**Subject: 3055 Richmond Holding Inc. – 3055 Richmond Road – Site Plan  
Control Application 7<sup>th</sup> Submission - City File No. D07-12-22-0147**

On behalf of 3055 Richmond Holding Inc. (the “Client”), please find enclosed, the seventh submission for the Site Plan Control (File No. D07-12-22-0147) Application, located at 3055 Richmond Road, in the City of Ottawa. The enclosed resubmission package addresses the City’s comments received on October 30, 2025.

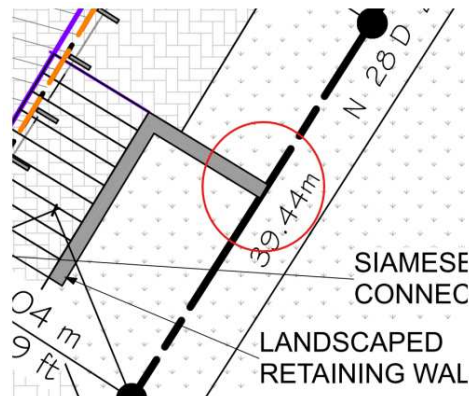
**1. Please label the rear yard landscaping/amenity area, and provide the dimensions.**

**a. Further, please clarify on the site plan how the rear yard amenity area is accessed, and indicate any provided pathways.**

**City Response: Acknowledged. If rear yard area is included in amenity area calculation, please add a note identifying it as an “amenity area”.**

The Site plan has been modified to clarify amenity area vs rear yard soft landscaping. Rear yard soft landscaping is 167.9 m<sup>2</sup> and amenity area is 180.6 m<sup>2</sup>.

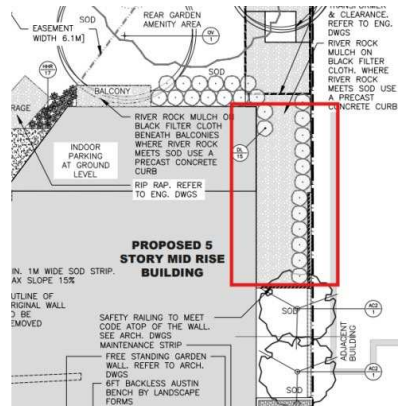
**6. Please review rooftop area, currently labelled as “public balcony”. If no public access is intended, it should be rebelled as above.**

This was always intended as a public space, no changes made.

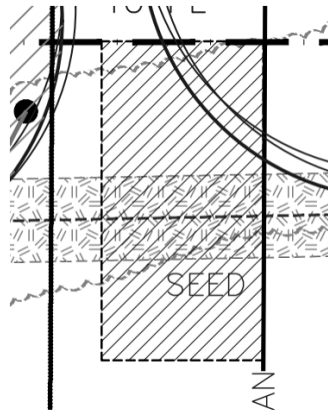
**8. Is there an opportunity to replace some of the river rock along the east side of the property, between the proposed trees and transformer, with additional trees or other plantings?**

Tight space limitations, the neighbour's retaining wall and minimal light make it difficult for any small tree to grow other than Nannyberry which is a large shrub. It does well in shade and we have added three to the plan.
